BENTLEY MARK VI

MODIFICATIONENGINE OIL FILLER CAP WASHER.

REPLACEMENT OF TAPPETS.

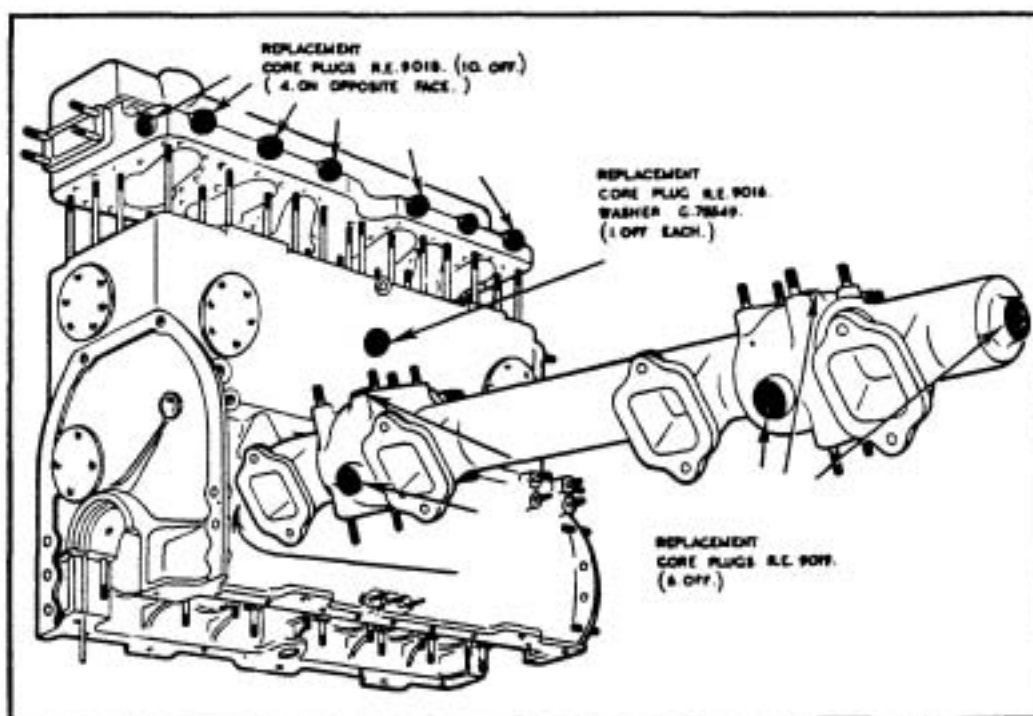
Bentley Service Bulletin BB-19 deals with the replacement of engine core plugs on a Category 2 basis, conditional upon partial or complete overhaul.

The following illustration gives fuller details of the location of the core plugs to be replaced, together with replacement part numbers.

It should also be noted that if a coolant leak develops from any of the core plugs when the engine is fitted with the pre-modified type, this may indicate that a state of corrosion exists in other core plugs caused initially by the engine remaining drained of coolant for lengthy periods of storage or shipment. If a leak is apparent therefore, the instructions given in Bulletin BB-19, limiting this modification to overhaul cases only, must be disregarded, and all core plugs replaced with the modified type.

FIG. 1 OLD TIMING MARKINGS
ON FLYWHEEL, LEFT-HAND
DRIVE CARS.

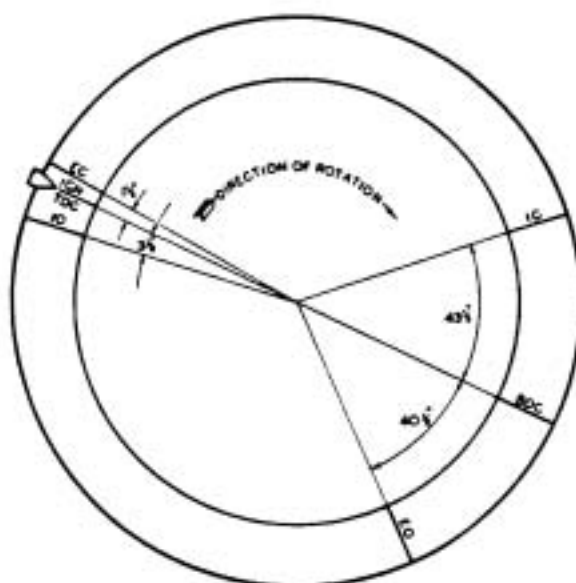
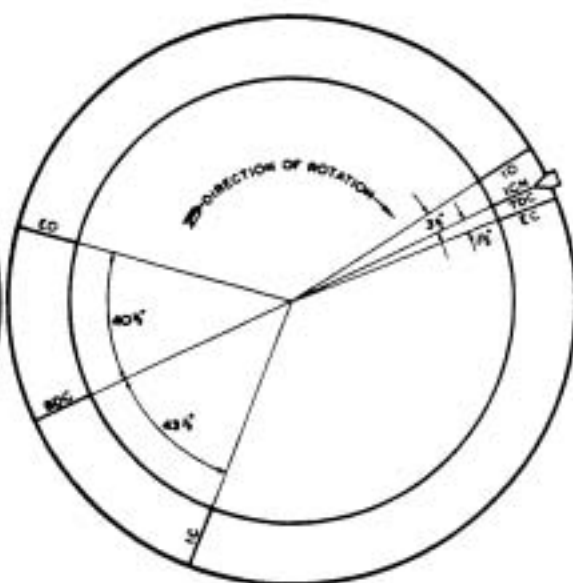
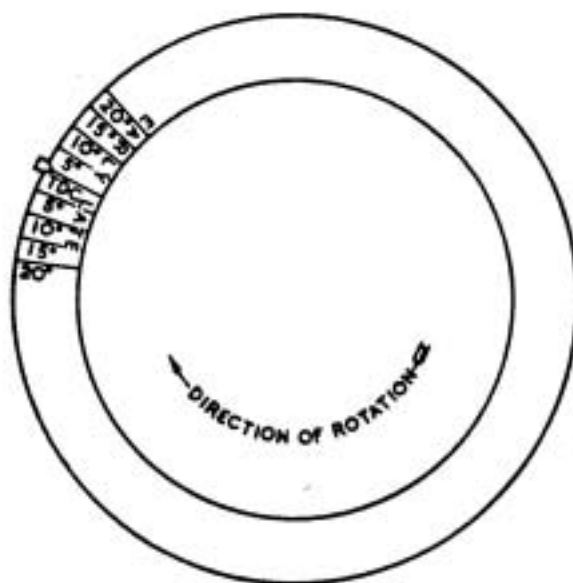
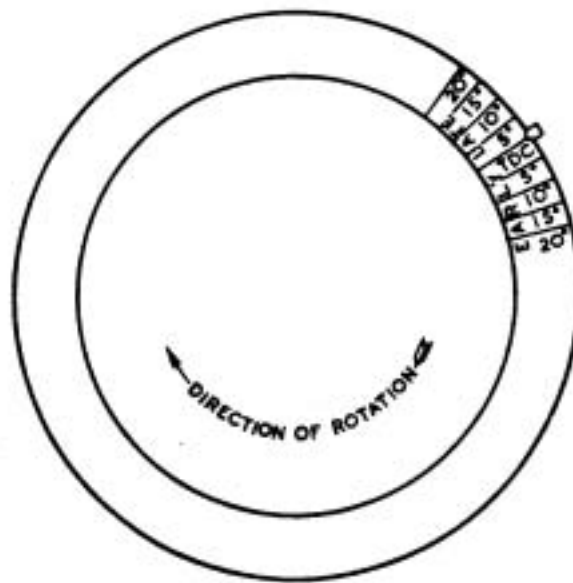
Early type flywheels are marked as shown in Fig. 1 and 2. Later type flywheels and replacement flywheels, will be marked as shown in Fig. 3. It will be noted that the T.D.C. mark only is shown with additional markings at five degree intervals from 5° to 20° on either side of the T.D.C. mark designated EARLY and LATE.

FIG.1. SECTION - CYLINDER-SHOWING COUNTERBORE.

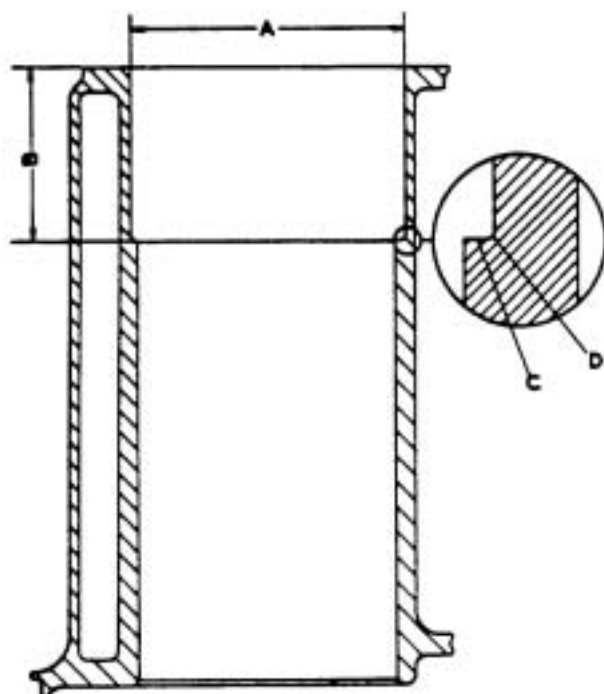
NOTE: If, when measuring the diameter of a counterbore ('A' Fig.1), it exceeds 3.6265" (92.11 m/m), it will be necessary to fit an R-4610 oversize short liner. This liner is marked with white paint and has an external diameter of 3.631" to 3.632" (92.23 to 92.25 m/m), and one should be selected that will not allow an interference exceeding .004" (.1 m/m), or less than .0025" (.06 m/m).

FIG.2. SECTION - CYLINDER - SHORT LINER IN POSITION.

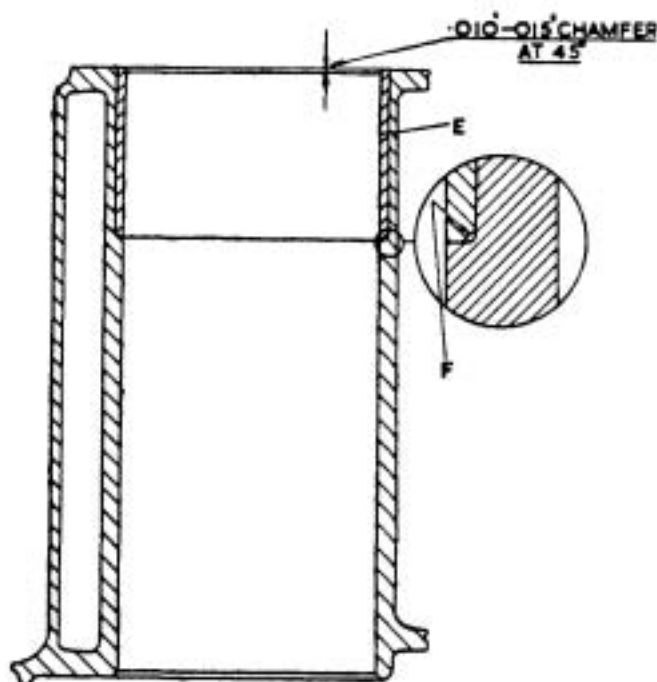
- (ix) With a half-round scraper, cut a .010" to .015" (.25 to .38 m/m) chamfer at about 45° at the upper end of each liner, as shown in Fig.2.
 - (x) If removed, replace the cylinder head holding down studs.
 - (xi) Next, hone the bores to the required standard oversize diameter. (See table 'a' of Para.1). Due to the difference in textures of the liners and the cast iron cylinders, special care should be taken when honing to guard against the possibility of scoring.
3. TO BORE A CYLINDER BLOCK TO A STANDARD OVERSIZE DIAMETER ON WHICH SHORT LINERS WERE ORIGINALLY INCORPORATED (CHASSIS NO.B-144-DA AND ONWARDS):

FIG.3. SECTION - CYLINDER - TWIN LINERS IN POSITION (3.500" DIA. BORE ENGINE).

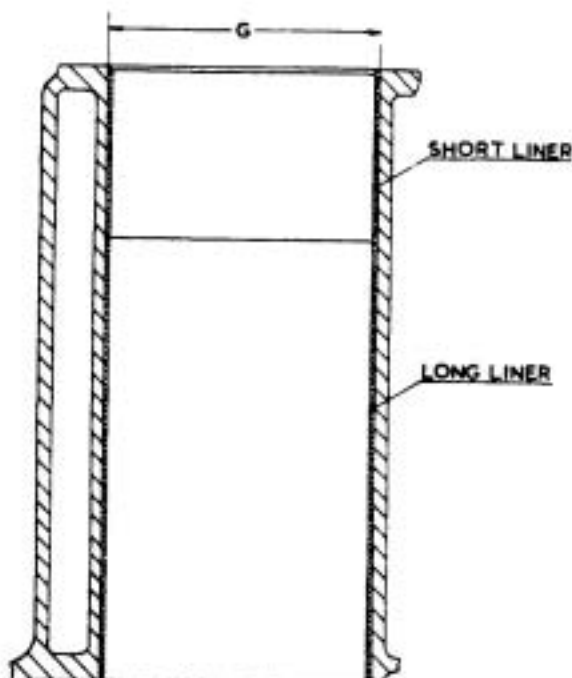
- (vi) Again set up the crankcase on the boring machine with the upper end of the 3.625" (92.07 m/m) dia. counterbore CONCENTRIC with the boring cutter and bore out the cylinder in stages, the whole of its length, (See G Fig.3), to a diameter that will allow the correct interference fit between the cylinder and the pair of matched liners. The finish of the bore must be a MACHINED AND NOT A HONED FINISH, prior to pressing in the liners.

PLAIN (TOP) FACE.

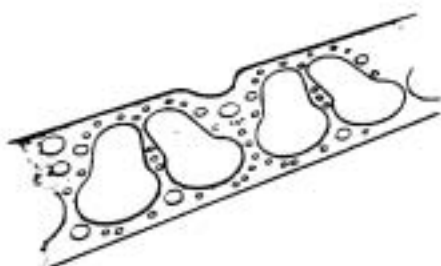
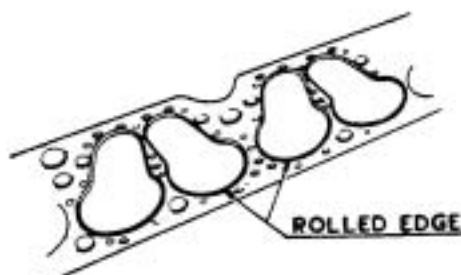
Retailers are advised that the correct procedure when fitting replacement C & A cylinder head gaskets in service is to ensure that these are fitted with the plain face uppermost and the rolled, or lapped, face to the cylinder block.

As an aid to recognition the characteristic differences between the top and bottom faces of the gasket are illustrated in the above two sketches. A further means of identification is provided by the word "TOP" which will be found stamped between Nos. 3 & 4 cylinder openings on the plain face as shown.

FIG.1-ADAPTOR-OIL FEED(EARLIER TYPE)

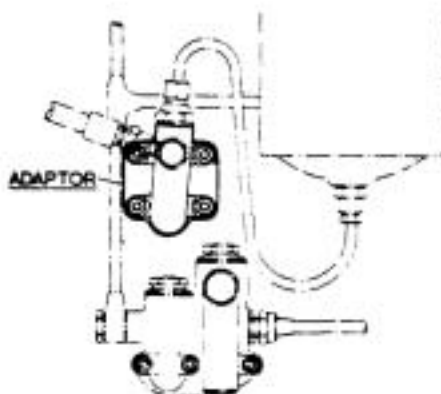
SCHEME 'A' conforms to the layout shown in Fig.3, and is relatively simple in installation, being confined to external alteration only. It can be applied to engines, the crankcase of which have the adaptor facing referred to above. Generally speaking, this modification to the crankcase was first introduced at the commencement of 'H' series to provide a means of employing full flow filtration on unit test, and in anticipation of the scheme becoming standardised later. Crankcases of this type may be recognised by reference to Figs. 1 & 2, which show special adaptors used in conjunction with the original By-Pass Filters.

FIG. 4. SECTION SHOWING MODIFICATION TO CRANKCASE FOR OIL FEED STANDPIPE.

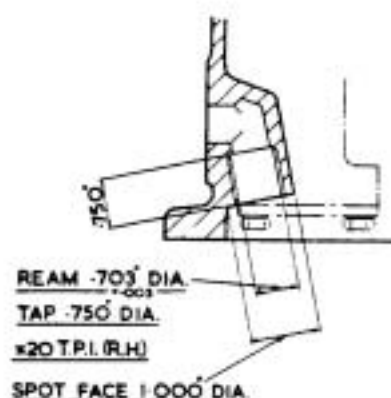
- (i) Remove the oil relief valve overflow pipe, (11/16"dia) from the interior of the crankcase, by twisting to shear the small securing taper pin. With a suitable punch tap out the remaining portion of the pin from the crankcase. For position of pin, refer to point 'A' Fig.7. Remove the sheared portions.
- (ii) Plug the pin hole by first tapping it with the 3-EA taper tap sufficiently to make the screw, K-1813 an interference fit. To prevent the screw protruding into the bore of the overflow pipe hole, shorten it to $\frac{3}{8}$ " (9.5m/m) measured from underside of head. Fit screw and remove head flush with crankcase and finally peen over to secure.
- (iii) With the R-4743 (.703"dia) piloted parallel reamer, ream out the hole in the crankcase from which the overflow pipe has been removed and tap .750"dia 20 T.P.I.-R.H. using both taper and plug taps(See Fig.4).

FIG. 8. SCRAP VIEW SHOWING CRANKCASE LUG ('A').

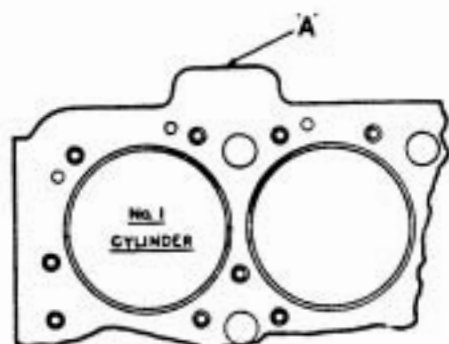
- (vi) File back the face of the crankcase front lug, 'A' Fig. 8 and fit the stud (1) KB-751/2 as described in sub-para. (iv) of Para. 3 for Scheme 'A'.

NOTE: In the unlikely event of the lug having been machined back on an engine prior to 'H' series chassis, then it will be necessary to fit the circular distance piece (23 Fig. 10) interposing it between the filter mounting plate and the lug when fitting the mounting plate and filter assembly to the crankcase as described in Sub-para. xv.

FIG. 9. FRONT ELEVATION - FULL FLOW OIL FILTER.

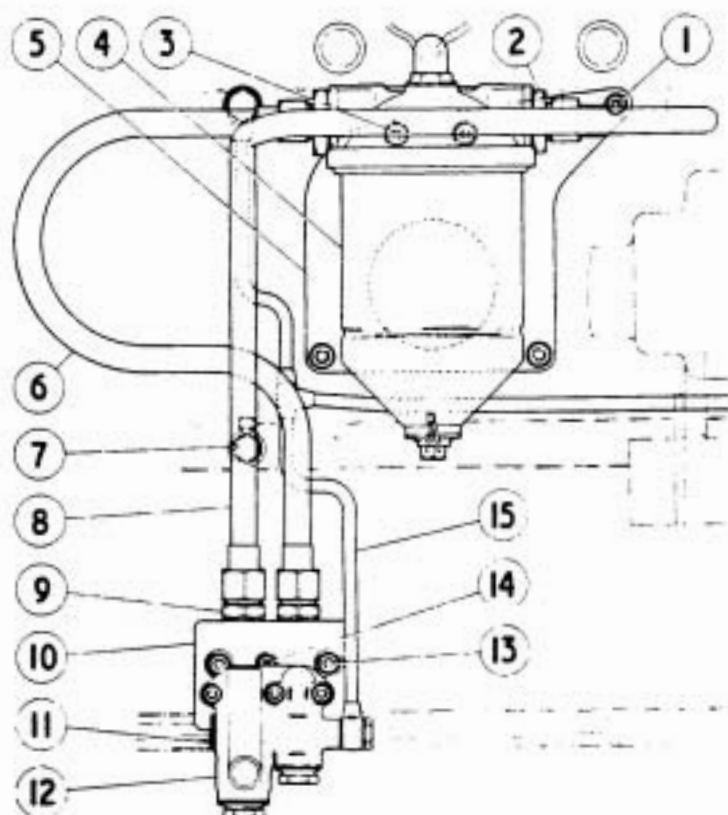
- (xi) Remove the union from the oil relief valve unit and fit the core plug (11) and joint washer. Place the unit and the Vellumoid joint (EB-3953) on to the transfer block. While tightening up the three nuts to secure, check that the end of the centre stud (14) or nuts securing the transfer block to the crankcase do not foul the casing of the oil relief valve unit. The unit is inverted for fitting under this arrangement as shown in Fig. 9.

FIG. 11. CRANKCASE LOWER HALF.

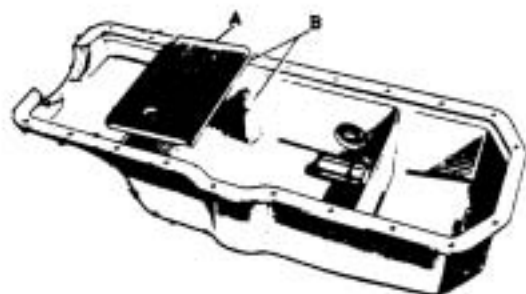
- (xiii) When offering up the lower half of the crankcase, it will be found that the union nut securing the oil feed pipe to the standpipe (21) fouls the oil baffle ('A' Fig.11) and the locating lug at points 'B'. Remove the baffle and file the lug until it just clears the nut and then file the edge of the baffle to suit. It may also be necessary to file the inside of the lower half of the crankcase to clear the nut. Refit the baffle.

FIG.1 LOCATION OF CORE PLUGS

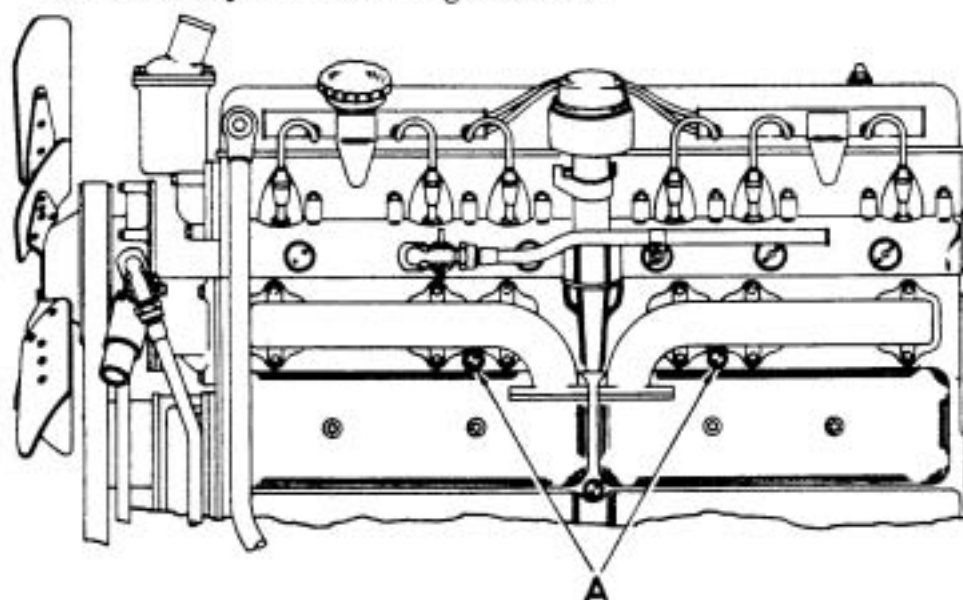
On certain $\frac{3}{8}$ " bore engines two aluminium alloy core plugs were fitted on the left hand side of the crankcase above the tappet covers as shown at A Fig.1.

The aluminium plugs have proved subject to corrosion in service and are to be replaced with cadmium plated steel core plugs and aluminium washers as a retrospective modification. Retailers are asked to carry out replacement on all affected cars in their area when they are next being serviced.

- (i) Drain the cylinder block.
- (ii) Remove the aluminium core plugs, clean the threads with the tap provided and fit the steel plugs and aluminium washers.
- (iii) Refill the cooling system.

FIG.1.
RADIUS ON FLYWHEEL TEETH.

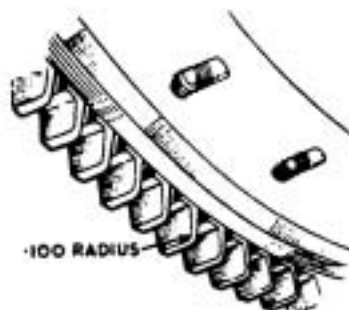
The flywheel ring gear teeth are also to be radiused .100" (2.54 mm) to remove the sharp corner on the engaging face.

Fig.1 Outer Lip Proud of Inner Sealing Face.

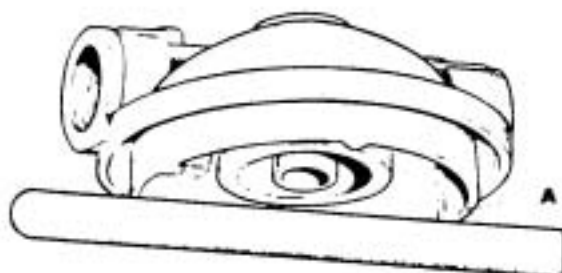
It has been established that on a small number of 'Vokes' Full-Flow Oil Filters it is possible for the oil to pass across the filter head without passing through the filter element. This condition is only possible when the outer lip of the filter head (see A Fig.1) stands proud of the inner sealing face.

Therefore when the bowl of the filter is removed to change the filter element and seals, on the 5,000 miles service schedule, Retailers should check the filter head with the aid of a straight edge as illustrated in Figures 1 and 2.

If the outer lip is found to stand proud of the inner sealing face (see Fig.1), a modified 'Top Cap' (see Fig.3) should be fitted and the original discarded.

If the inner sealing face stands proud of the outer lip (see Fig.2) the original 'Top Cap' (as shown in Fig.4) can be retained. For future replacements only the modified 'Top Cap' will be supplied.
